## **REVIEW OF ADDITIONAL INFORMATION PROVIDED BY ALC**

A town planning application has been submitted to the City of Ballarat (Council) for a residential subdivision at Lot 1 Heinz Lane, Invermay Park, located in Ballarat. Acoustic Logic Consulting (ALC) have prepared an acoustic report that Marshall Day Acoustics Pty Ltd (MDA) have undertaken a peer review that is documented in letter reference: *Lt 002 20200608 Peer Review – Lot 1 Heinz Lane Invermay (Lt 002)*.

### **Document reviewed: 20211112BAWA\_R4\_Response\_to\_MDA\_Comments**

**330 Heinz Lane, Invermay Park - Response to MDA Comments****1 INTRODUCTION**

Figure 2 – Predicted traffic noise levels - No Berm

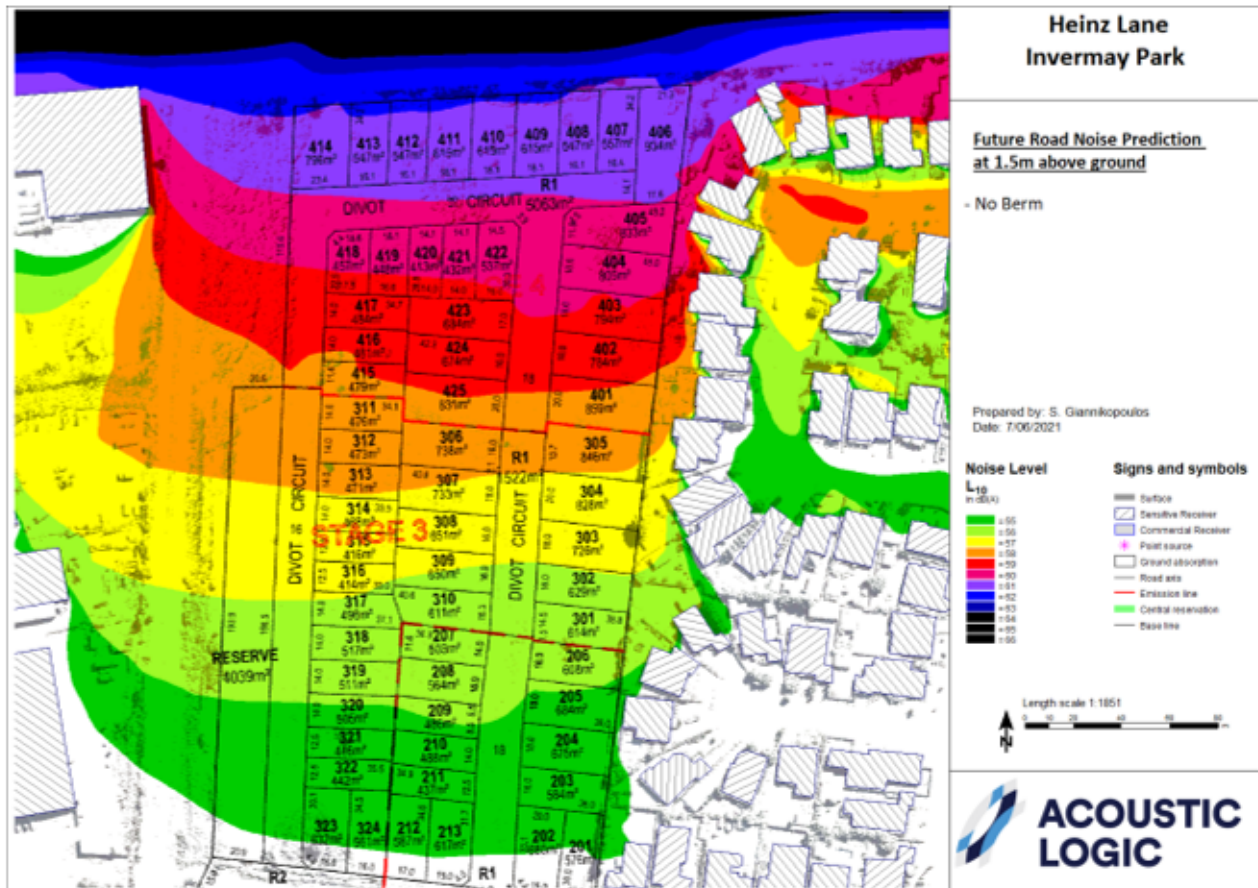
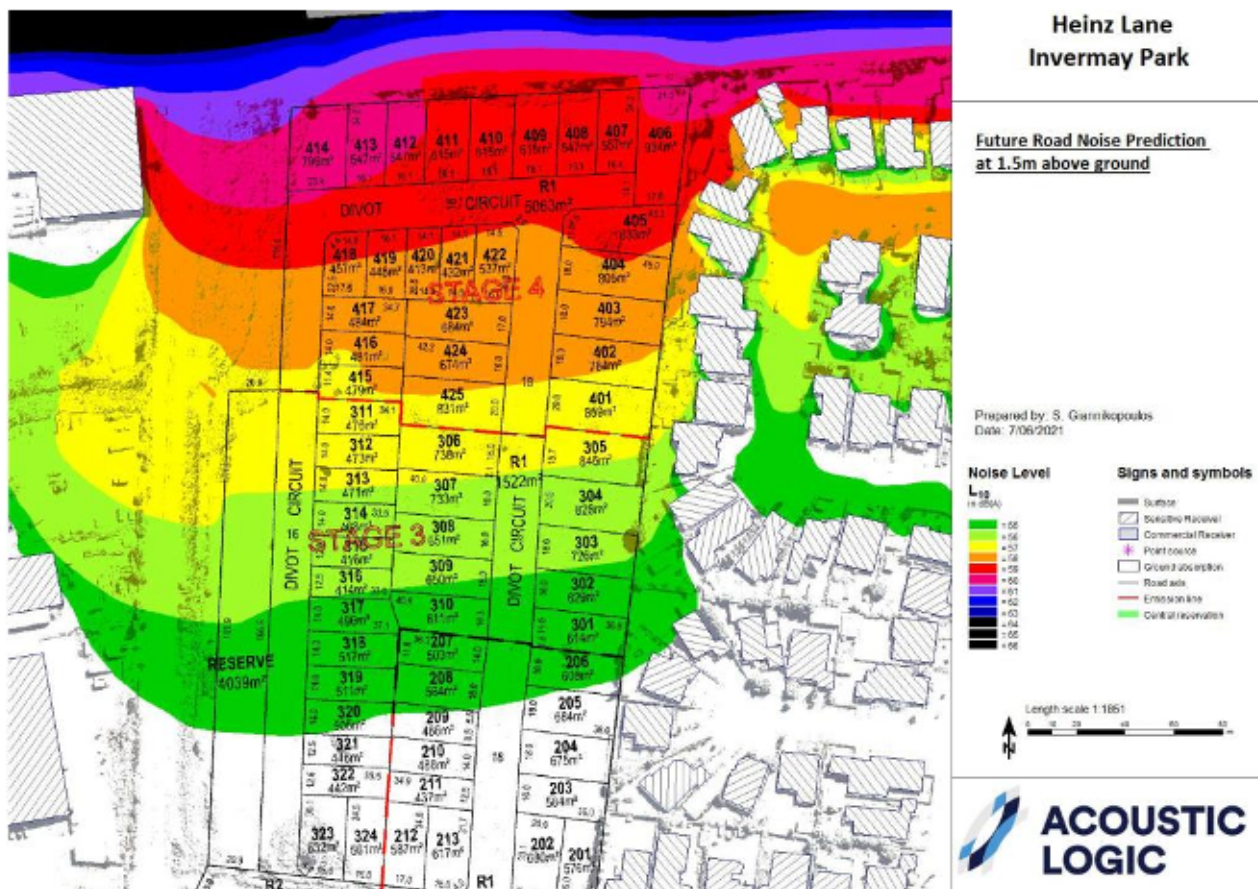
21	Noted
22	Noted. Reviewed in conjunction with the noise contour maps Figure 2 and Figure 3 (page 4 – <i>ALC Response</i> )
23	Confirm the metric of the traffic data i.e. is it Annual Average Weekday Traffic (AAWT) or does it represent 18-hour conditions?
24	Noted
25	<p>If a similar noise level has been measures at Position 7 and 8 then it would be a reasonable assumption to use the same <math>L_{Amax}</math> level for the length of track.</p> <p>ALC to confirm that the model been calibrated to confirm that the <math>L_{Amax}</math> level is as per the level measured at Position 7 and 8.</p>
26	<p>Noted</p> <p>This was noted given that the trains will likely slow down on approach to the level crossing on Heinz Lane, and then speed up moving away from the level-crossing. If ALC observations are that train speed remains constant, and there is no variation in the track (i.e. points), then we have no further comments.</p>

3	Medium	Section 2 Site Description, Figure 2 – Extent of Berm, Page 5	<p>The extension of the berm is not explained in the report.</p> <p>It is assumed that this will assist to mitigate the propagation of traffic noise across the site?</p> <p>What degree of noise mitigation does the berm provide?</p>
---	--------	---------------------------------------------------------------	-----------------------------------------------------------------------------------------------------------------------------------------------------------------------------------------------------------------------------------------

Appendix 1 presents detailed information on the proposed berm. The following comments are provided

1. The berm will be a natural berm constructed from soil and fill
2. Will be an extension of the existing natural berm located directly to the east.
3. Comparison of noise from vehicle movement on the Western Freeway with and without the berm is presented below.
4. Analysis indicates that construction of the berm will reduce noise levels by approximately 2 dB(A)

**Figure 4 – Background noise monitor location**

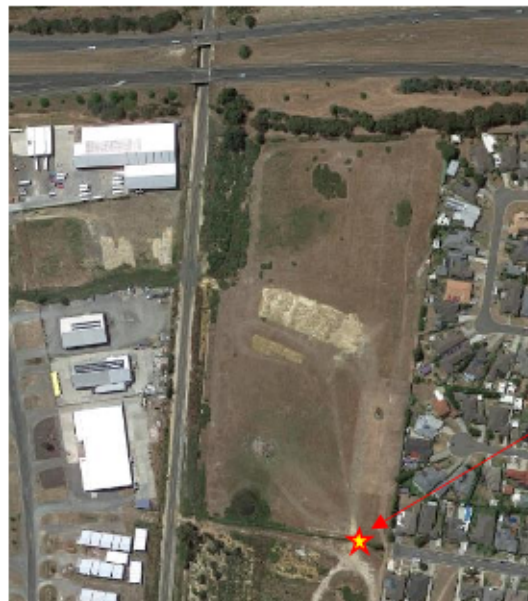
MDA Ref No.	MDA Comment
4	<p>Given the supplementary noise measurements are higher-than-neutral background conditions, what noise sources are contributing to the ambient noise level in this location?</p> <p>Have the supplementary measurements been reviewed to consider the weather conditions i.e. wind speed, wind direction, precipitation etc as per the Noise Protocol methodology?</p>
5	Noted
6	<p>It is acknowledged that the modelling of traffic noise will consider favourable wind conditions. However, as per Item 4, we request that ALC outline the weather conditions taken into account for Location 7 (i.e. the industrial noise monitoring location) and also the supplementary noise monitor location to measure noise from the Boral facility in the north-west of the site.</p> <p>It would be expected that this is discussed in the AL report, and the impact on the assessment detailed.</p>
7	Noted.
8	Noted. However, how was the supplementary monitoring provided in Table 3 used in the assessment, if at all?

4	High	Section 4 Noise Level Measurement and Section 4.1 Measurement Locations, Page 7 and 8	MDA seek clarification from ALC to describe if the background noise measurements are influenced by extraneous noise from surrounding industry? If so, how has this been taken into account when deriving noise criteria?
---	------	---------------------------------------------------------------------------------------	--------------------------------------------------------------------------------------------------------------------------------------------------------------------------------------------------------------------------

The noise level is dominated by transportation noise and has been based on measured background noise level and appropriate for site.

In addition, AL has conducted supplementary background measurements in the location indicated in the figure above to validate the results.

The measured noise levels determined from additional supplementary monitoring are presented in the table below (Refer to Appendix 2)
